SOLARRESERVE KOTULO TSATSI ENERGY CONCENTRATED SOLAR (CSP) 2 FACILITY, NEAR KENHARDT, NORTHERN CAPE PROVINCE		
COMMENTS RECEIVED ON THE FINAL EIA REPORT FOLLOWING 21 DAY REVIEW PERIOD AND SUBMISSION TO DEA AND LATE COMMENTS		
NO.	COMMENT/ISSUE RECEIVED	RESPONSE TO ISSUES RAISED
COMMENTS RECEIVED FROM PHS CONSULTING ON BEHALF OF LEOPONT 340 PROPERTIES (LEOPONT) (LANDOWNER – MR. J.W BASSON), DATED 31 MAY 2016		
Reason for Objection

Figure 2: Source - SEA www.csir.co.za & DEA

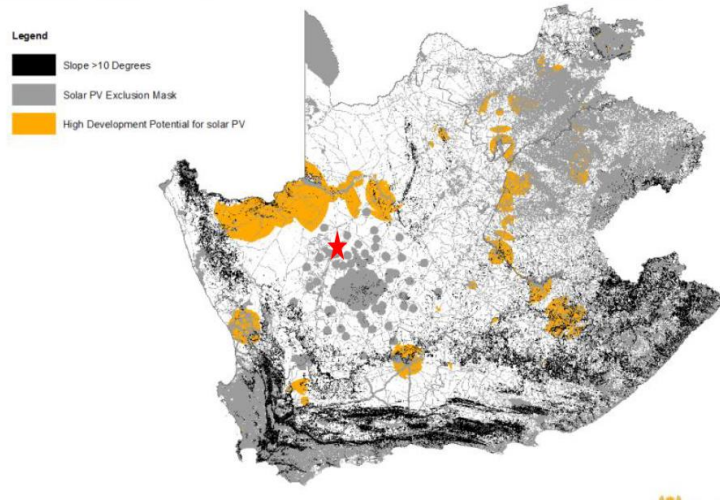
G	<p>The SEA process considered both negative and positive mapping to identify RE development areas. Positive key factors including</p>	<p>The extracted map is for high development potential areas for PV and wind only. This does <u>not</u> apply to CSP technology, nor has this been gazetted to</p>

<p>transmission loss, local municipalities with high social need and high potential for development, priority areas for renewable energy manufacturing and import activities, and existing transmission infrastructure were considered. This also applies to CSP's.</p> <p>Negative mapping entail environmental and technical constraints to eliminate areas with highly sensitive features consisting of environmental features (e.g. protected areas and areas of known bird and bat sensitivity), existing and future planned land uses (e.g. agriculture), existing infrastructure (e.g. electricity grid), existing national plans (e.g. Square Kilometre Array electro-magnetic telescope project). This also applies to CSP's.</p> <p>The idea was to identify large clusters of land with the lowest environmental sensitivity, overlaid with the highest development potential areas per province. The priority development areas were then identified. Specialist scoping level pre-assessments were then undertaken in the REDZ for agriculture, landscape, heritage, terrestrial and aquatic biodiversity, birds, bats, and socio-economic sensitivities.</p> <p>Below is a map (figure 2) extracted from the CSRI & DEA SEA, the red star is the approximate location of the approved CSP. It is clearly outside of high development potential areas and within an exclusion area. The grey exclusions in this case relate to SKA reserve area, sensitive wetland drainage patterns and ecological corridors.</p>	<p>be used as a baseline for renewable energy infrastructure development in terms of the NEMA or any other infrastructure development legislation.</p> <p>PHS Consulting's inference that this applies to CSP is fundamentally flawed, however, the following should be noted:</p> <ul style="list-style-type: none"> - Only the dark grey areas are flagged as exclusion areas, and relate to SKA satellite stations. There is no direct overlap with the Kotulo Tsatsi site and the exclusion areas shown, or SKA sites. <p>In terms of the documentation released by the CSIR, 2015, the following should be noted regarding the DEA's position is concerning the REDZ, and that the need for detailed assessment at a project level, even within a Focus Area, would be required. The following is a direct quote:</p> <p>CSIR, 2015: "Scoping level pre-assessments of the biophysical and social environments have been undertaken as part of the SEA to produce sensitivity maps for the proposed REDZs. The sensitivity maps are based on the best available data, but are not sufficiently detailed to support project level decision making in terms of the National Environmental Management Act (NEMA) (Act 107 of 1998). The maps instead identify potential sensitivities to inform environmental assessment at a project level. Environmental Authorisation in terms of NEMA will be based on the outcomes of a project level environmental assessment and not the outputs of this SEA study."</p> <p>The REDZ nodes are not gazetted and areas falling outside of REDZ are not intended to be excluded from development of renewable energy projects. The purpose of the REDZ is to streamline applications falling within them. The study area of the proposed project has thus not been ruled out for development. In addition, it must again be noted that the REDZ proposed to be gazetted are for Solar PV and Wind technology projects only.</p>

A large area (20 700 ha) was subjected to scoping level assessments (for agriculture, landscape, heritage, terrestrial and aquatic biodiversity, birds, ecology, and socio-economic sensitivities) which identified no-go areas and lead to the proposed 1000 ha being chosen.
